#### **BROOKFIELD PROPERTIES**

X APPROVED AS NOTED  $\square$  DISAPPROVED RESUBMIT

# Coco Cigars

Shops at Merrick Park - Space 1250 320 San Lorenzo Avenue # 1250

**A-**1

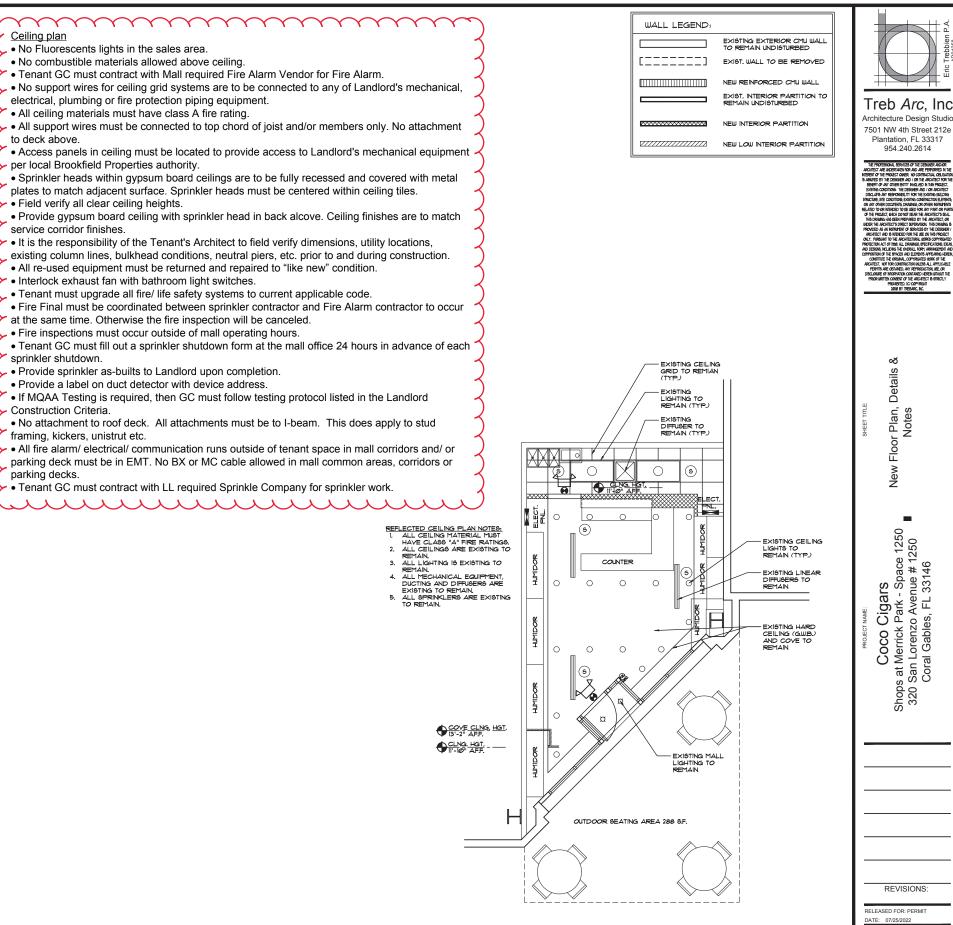
• Tenant's floor finish schedule should call for a minimum of 5/8" gypsum board smoke barrier running up the backside of the landlord bulkhead at the front lease line (from above the Tenant's storefront to the metal decking above) All work to be completed by the tenant.

- Repair mall tile to provide full continuous pieces installed to centerline of closure. Mall tile may be obtained from on-site mall team per criteria or lease cost.

- Do not dispose of construction materials or wash out grout or paint buckets into tenant sanitary lines. GC will be responsible for repairs to sanitary lines.

- Waterproofing is required in all wet areas. Landlord requires Laticrete 9235 or Mapei Mapelastic. 24hr standing water test is required
- Flush floor door stops

- Repair all cracked, chipped mall tile damaged from tenant construction.
- Provide a smooth level transition from mall tile to tenant flooring.
- Tenant must comply with local building and Fire code policies regarding movable fixtures

- Merchandise cannot be delivered to store until approval of final fire inspection and issuance of CO or TCO.
- Notify Landlord tenant coordinator of fixture delivery schedule.

- Tenant is responsible to make sure that the Mall tile to closure and along storefront is correct and consistent with the Mall tile design layout as it is intended

**D-**1

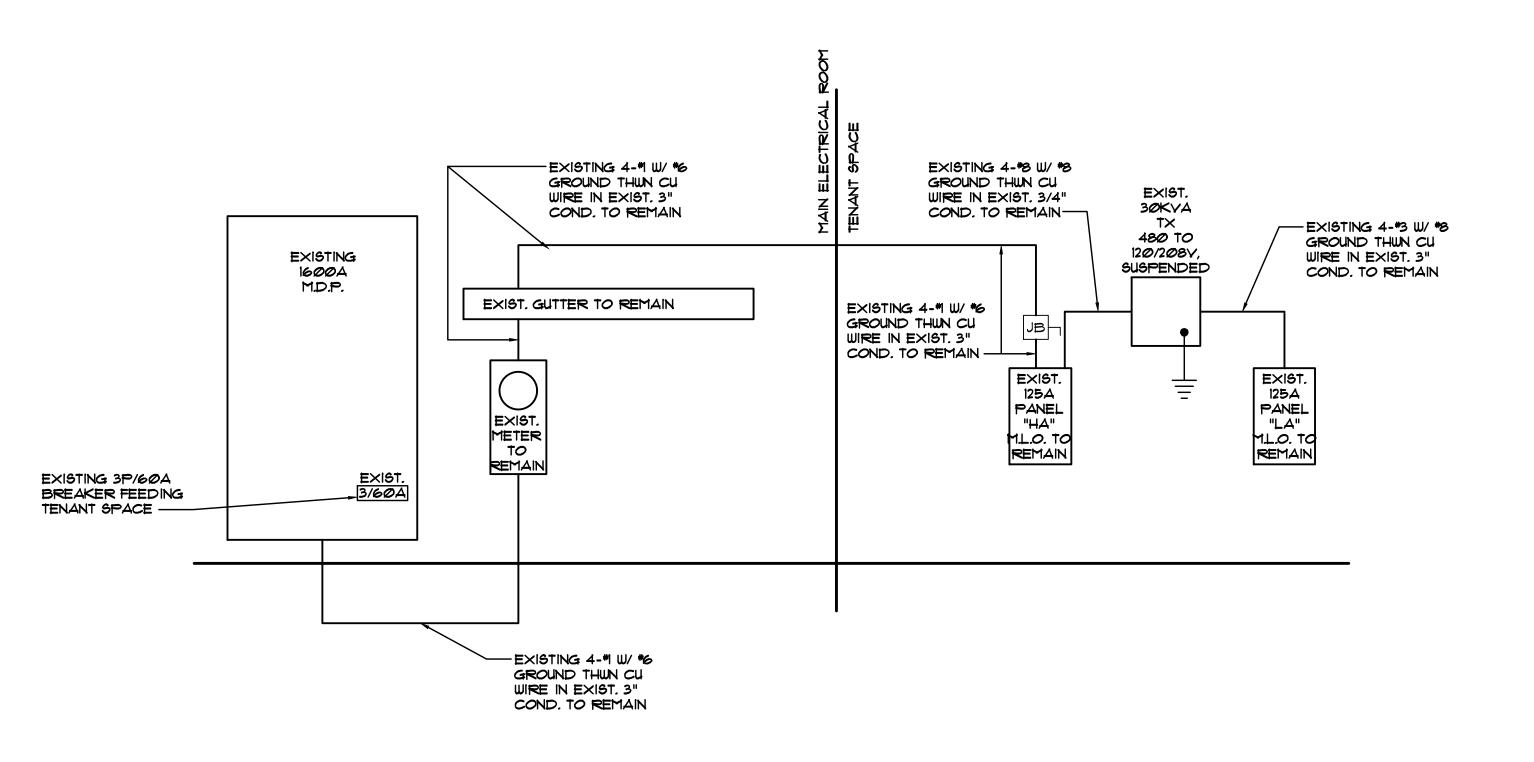
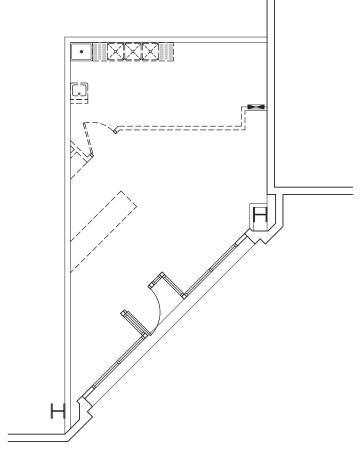
• Tenant GC to provide temporary construction barricade prior to commencement of construction, per instruction of local Brookfield Properties authority. Do not fasten to mall finish material.

- Barricade must be kept in good repair. Repair/ replace base, graphics etc as needed.
- Protect Landlord common area tile when installing barricade. GC to use 3/4" plywood over 6 mil visqueen where mall tile is present

- Tenant contractor will repaint and/or repair Landlord property (neutral piers, bulkhead, rear corridor, etc.) damaged during tenant improvements.
- Notify Mall required Fire Alarm required vendor before commencement of demo. All Fire alarm devices must be disconnected before commencement of demo.

- All noisy, dusty work must occur outside of mall operating hours. Demo materials may only be removed from the space outside of mall operating hours.
- GC must provide a walk off mat, and clean common area tile daily. GC will be charged for clean up of mall tile per the fee schedule in construction criteria.

- GC must notify landlord of all weekend and night work.
- Remove any abandoned utilities/equipment, such as HVAC units, curbs, ducts, plumbing vents, and wiring from the premises. Cap utilities at point of origin and coordinate this work with center management.

- Remove all abandoned utilities to the source.
- No utilities may be installed in Landlord provided demising walls.
- No attachment to roof deck. All attachments must be to I-beam. This does apply to stud framing, kickers, unistrut etc.

- All demising walls must be retrofitted to achieve and maintain a 1 hr rating. Bulkheads must be 1 hr rated.
- If monokote exists in the space, GC must repair damage to monokote that occurs during demo.

- • Protect Landlord's neutral pier and floor during construction/ removal of the barricade and throughout tenant

E-2

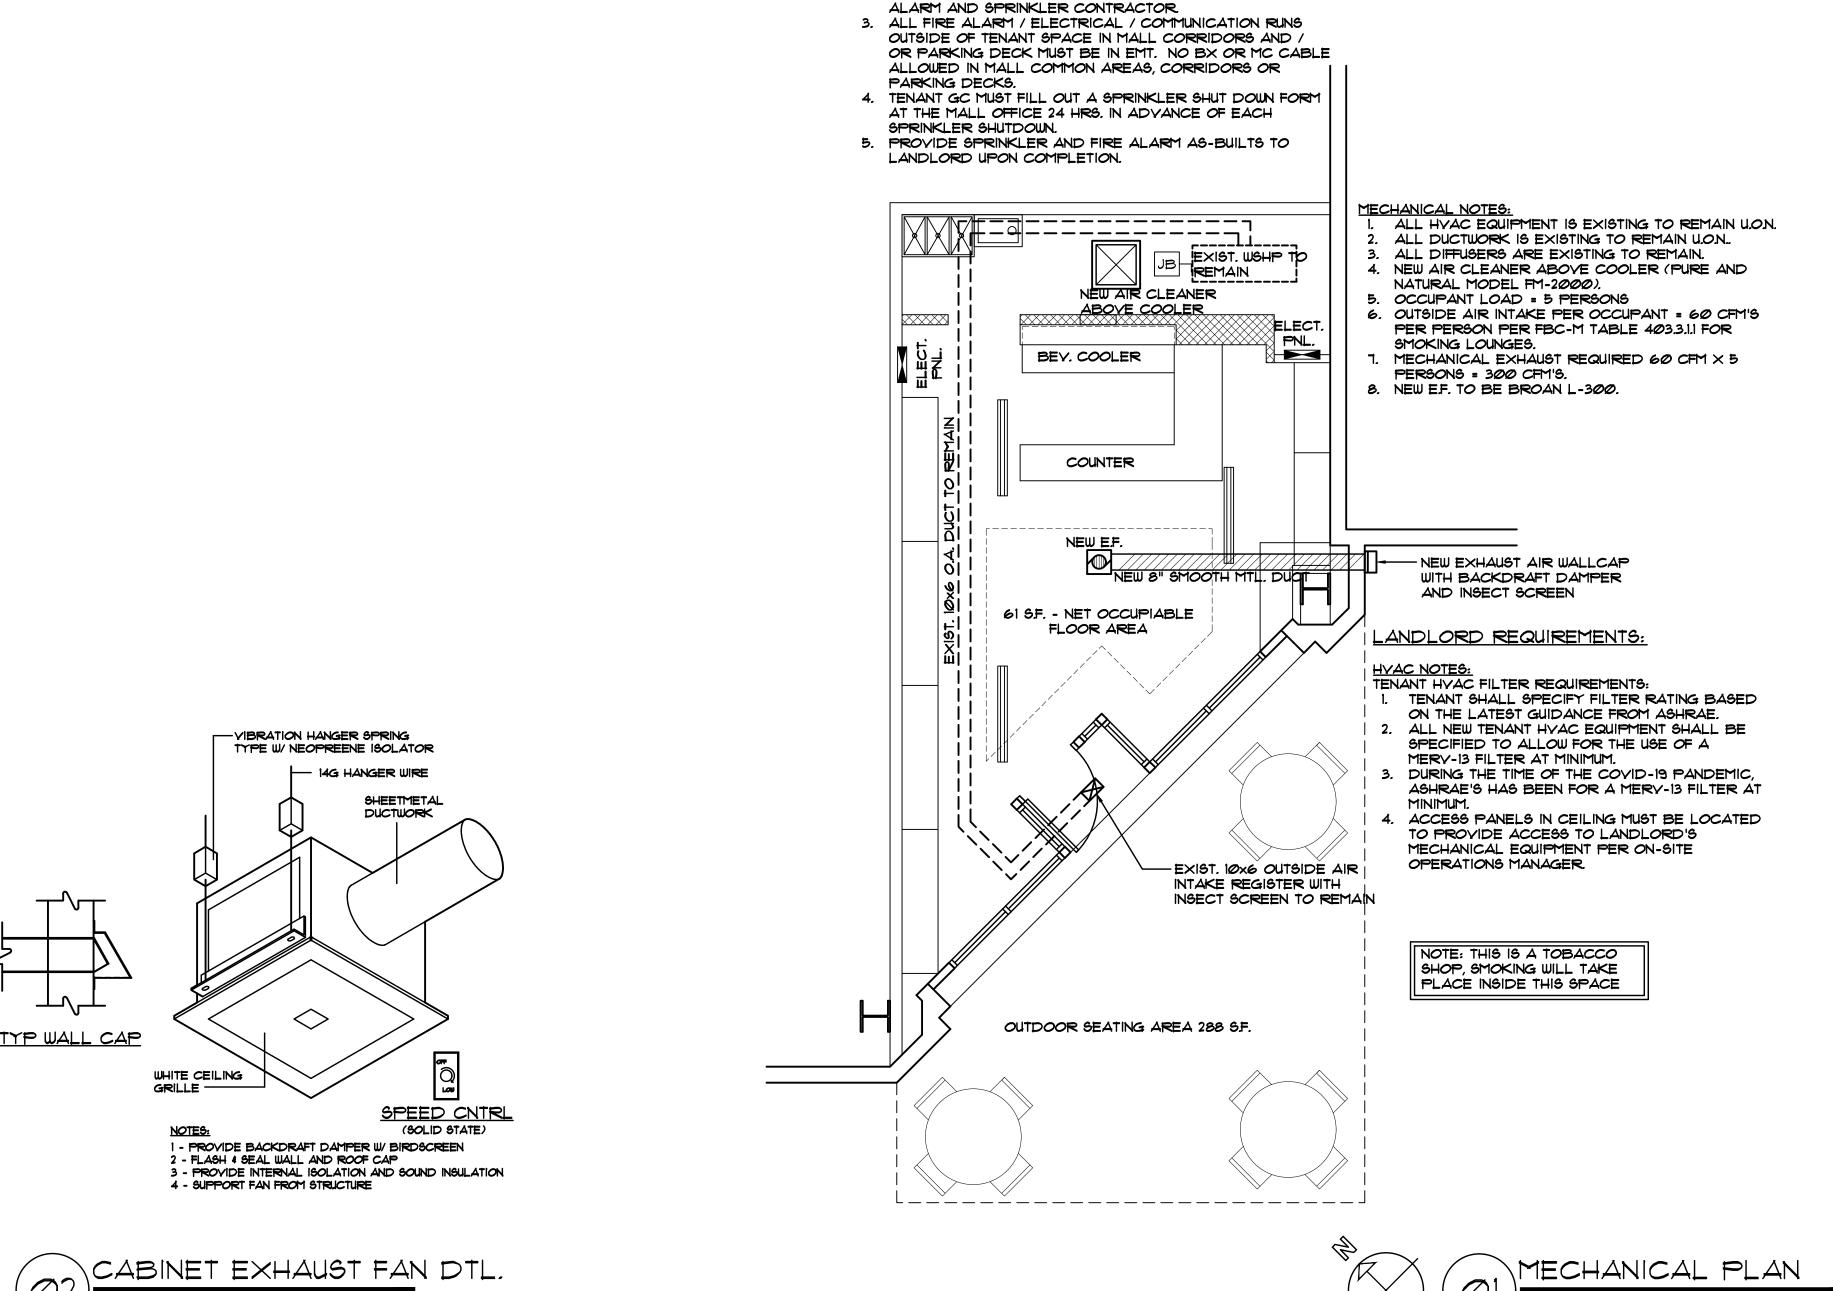
FIRE ALARM / SPRINKLER:

1. NO UTILITIES IN LANDLORD PROVIDED DEMISING WALLS.
2. TENANT GC MUST CONTRACT WITH LL REQUIRED FIRE
